TRUCK MEDIUM MC2 UNIMOG - ALL TYPES

LIFTING AND TIE DOWN ATTACHMENTS

MODIFICATION INSTRUCTION

- Reference: A. Change Authority PCR B Veh 161/86
B. Logistic Command (EME Division) programme 9/86

FIG 1 - CAST IRON LIFTING AND TIE DOWN ATTACHMENT TYPE 1

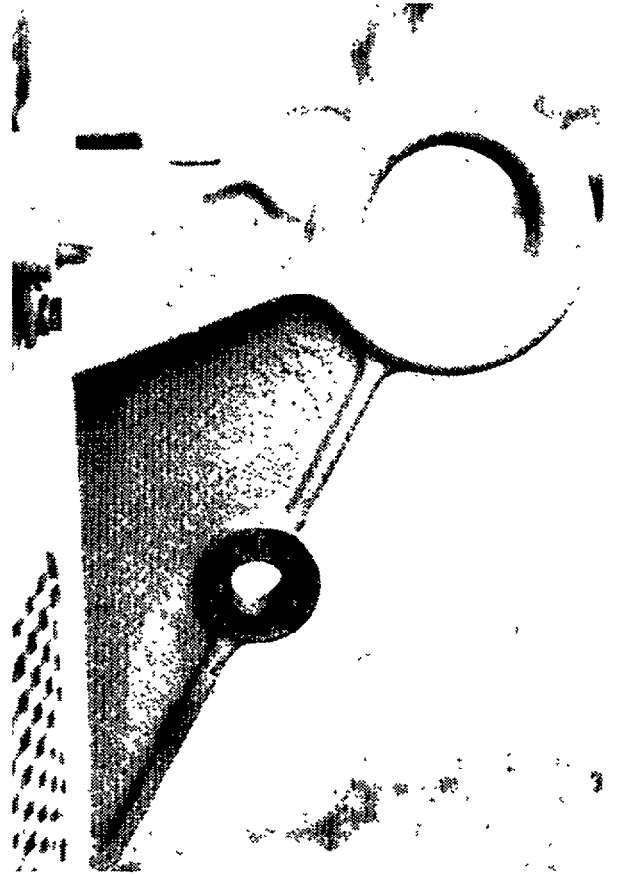
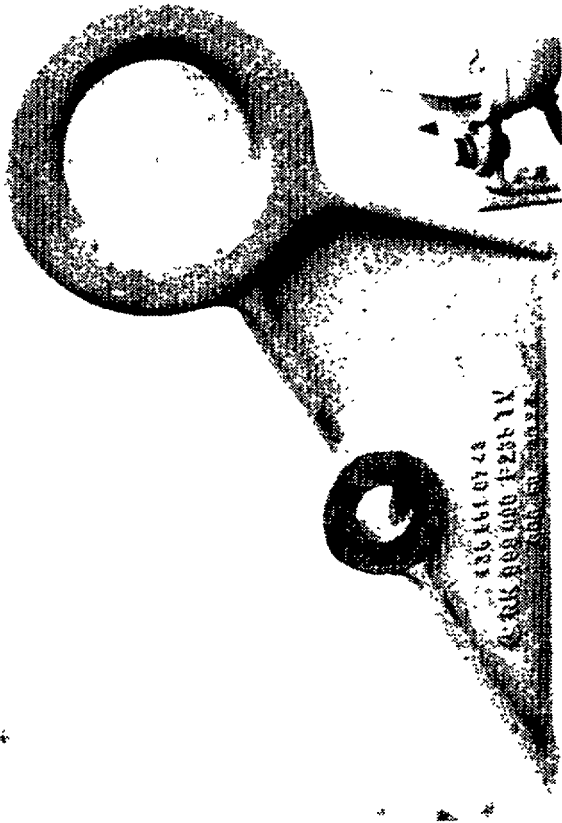
8. Inspect the attachments as detailed in VEH G 619-15 to ensure that they are the cast iron type (see also Figs 1, 2 and 3).

10. All vehicles fitted with Type 1 attachments (see Fig 1) are to have the mounting system modified by workshop personnel prior to installing the cast steel lifting eyes. Details of this modification are contained in paragraph 12.

12. To complete the Lifting Eye Air Certification modification proceed as follows:
 - a. Using a very low speed drilling machine and an 18mm diameter three fluted core drill (a special drill with 3 cutting edges), enlarge the two centre bolt holes in the chassis rails (refer item 13 of Fig 5).
 - b. Insert the tension sleeves (item 16 from Table 3).
 - c. Discard those items replaced by the Lifting Eye Air Certification modification kit (see Fig 5 and Table 3).

FIG 2 - CAST IRON LIFTING AND TIE DOWN ATTACHMENT TYPE 2

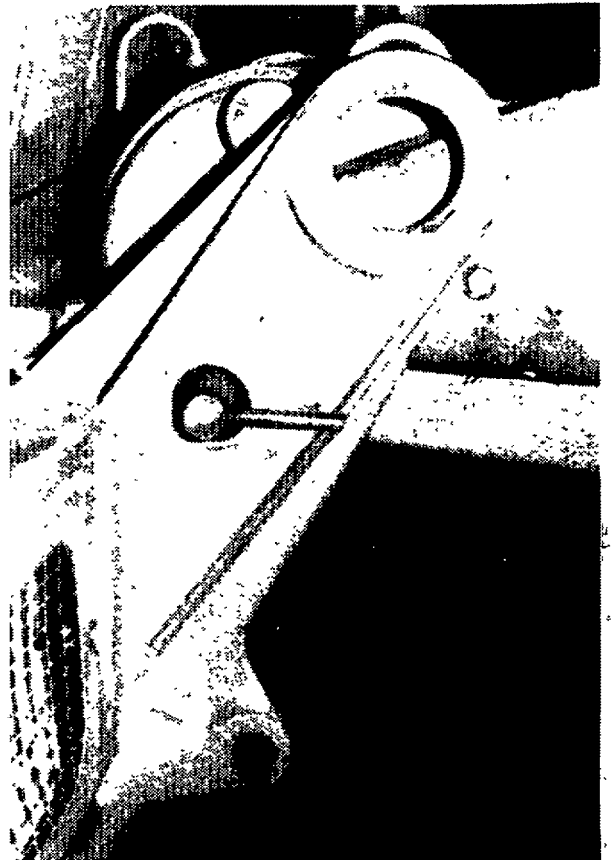
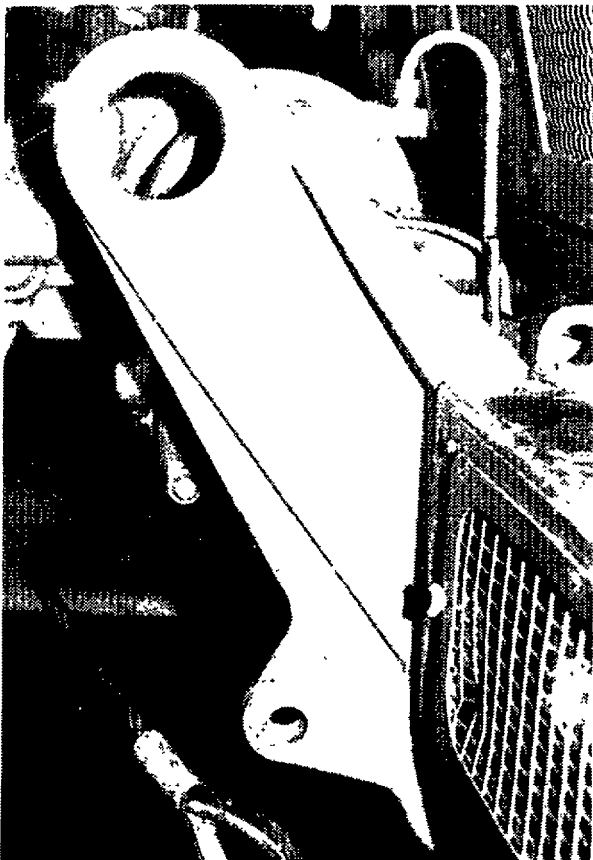
9. Prior to removing Type 2 attachments it is necessary to confirm that the Lifting Eye Air Certification modification has been completed. This modification strengthens the attachment mounting system so that vehicles can be safely air lifted using the lifting eye. Most vehicles fitted with Type 2 attachments have been modified wide reference B and these can be identified as follows:

1. Vehicles fitted with Type 2 attachments that do not have the Lifting Eye Air Certification modification are to be submitted to the nearest Mercedes Benz distributor together with the cast steel attachments (items 1 and 2 from Table 1) for modification in accordance with reference B. Units are to ensure that modification recording action is complete on return of the vehicle.

FIG 4 - IDENTIFICATION OF VEHICLES WITH THE LIFTING EYE AIR CERTIFICATION MODIFICATION COMPLETE

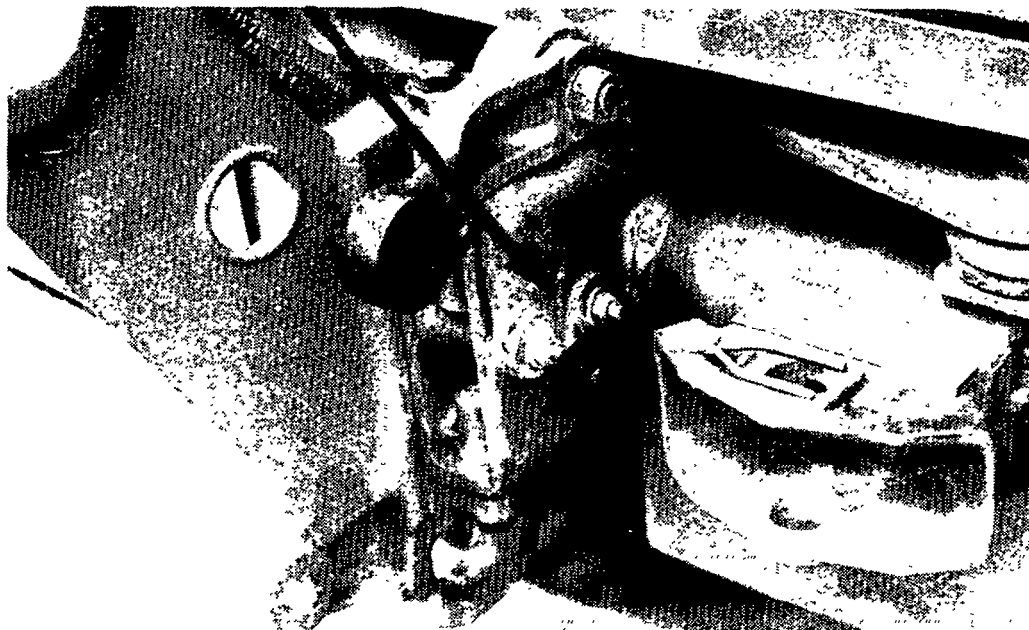
- a. The two centre horizontal mounting bolts are a smaller diameter than the lower bolt (see Fig 4).
- b. These smaller bolts will usually have 'M 10.9' on the head.
- c. The letter 'M' may be stamped on each chassis rail and on the centre of each lift tie down attachment.

Note smaller diameter bolts.

FIG 5 - CAST STEEL LIFTING EYE ASSEMBLY

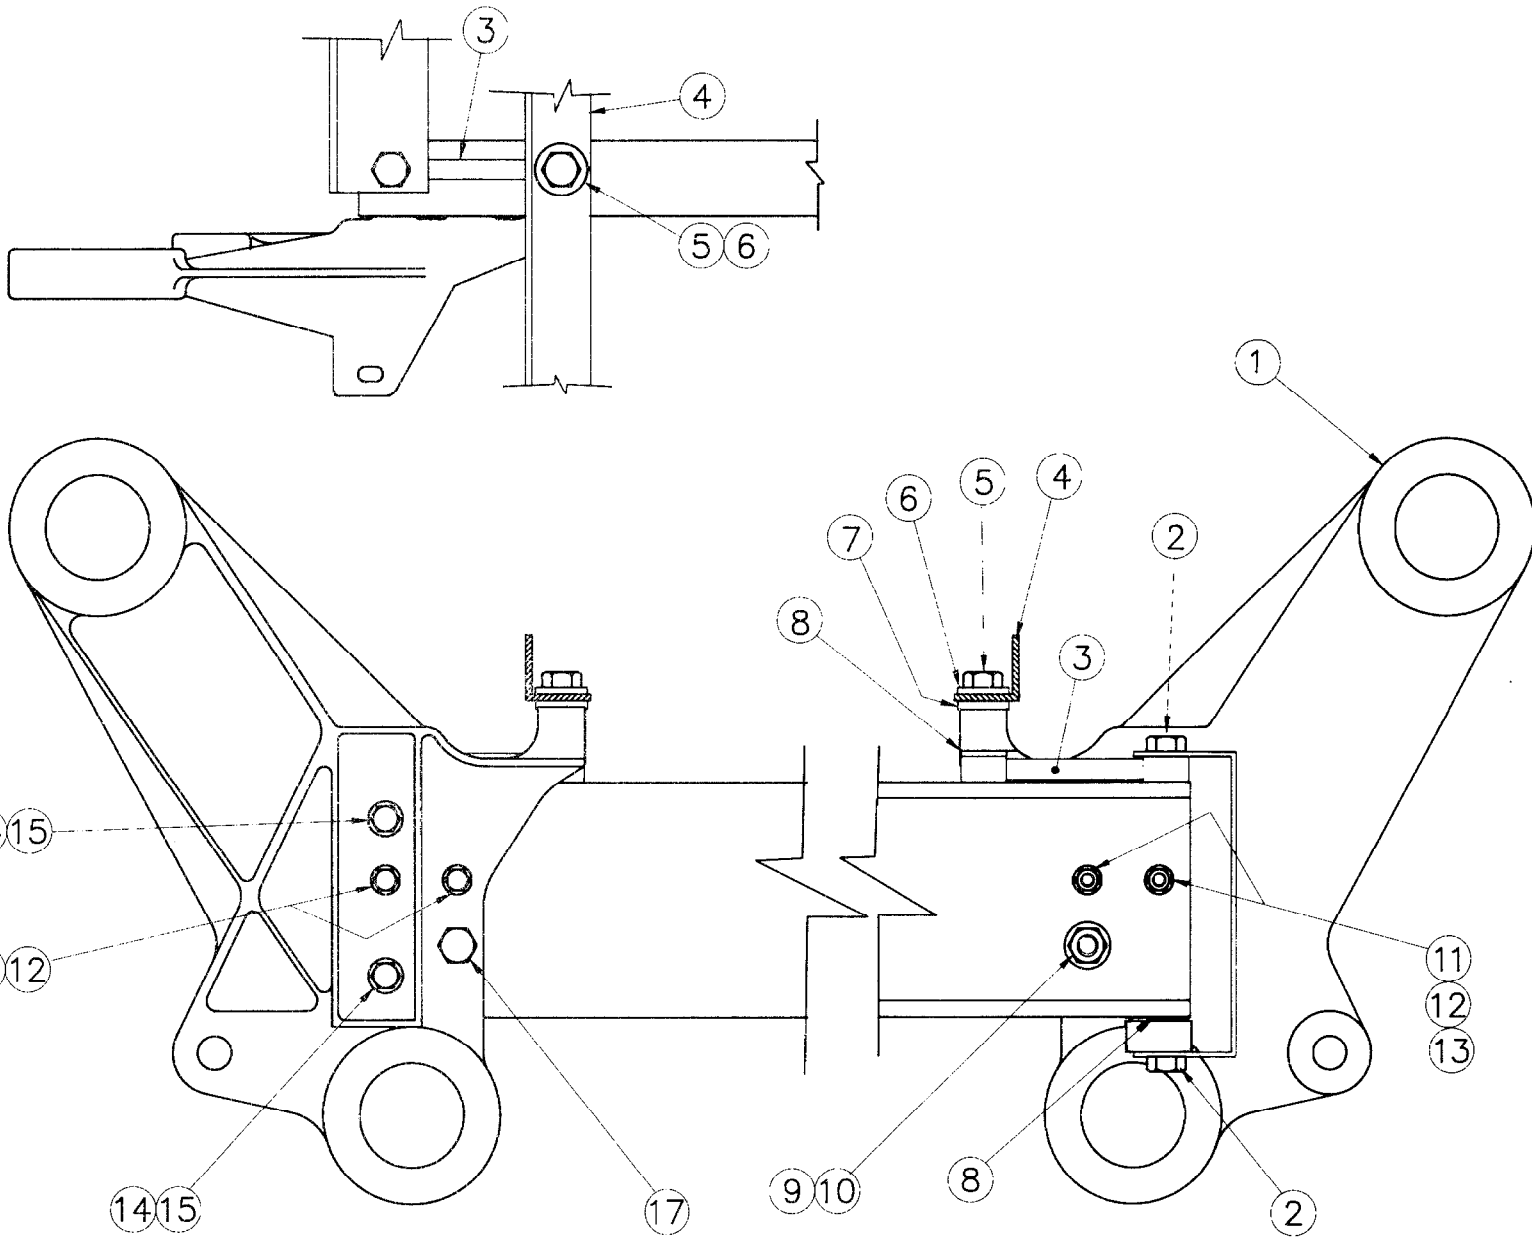
13. Fit the cast steel attachment as follows:
- a. Position the attachment on the chassis rails and fit the five horizontal mounting bolts (items 14, 16 and 17 from Fig 5).
 - b. Fit the spacer washers (items 4 and 5 from Table 1) as shown in Fig 5 so that there is no space between the casting and the chassis rail at the upper and lower mounting points.
 - c. Install the remaining mounting bolts and tighten all the bolts as specified in Table 4.

Serial	Description	Torque (Nm)
1.	VERTICAL SECURING BOLTS (ITEMS 2 AND 5, FIG 5)	240
2.	UPPER AND LOWER HORIZONTAL SECURING BOLTS (ITEM 14, FIG 5)	120
3.	CENTRE HORIZONTAL SECURING BOLTS (ITEM 16, FIG 5)	90
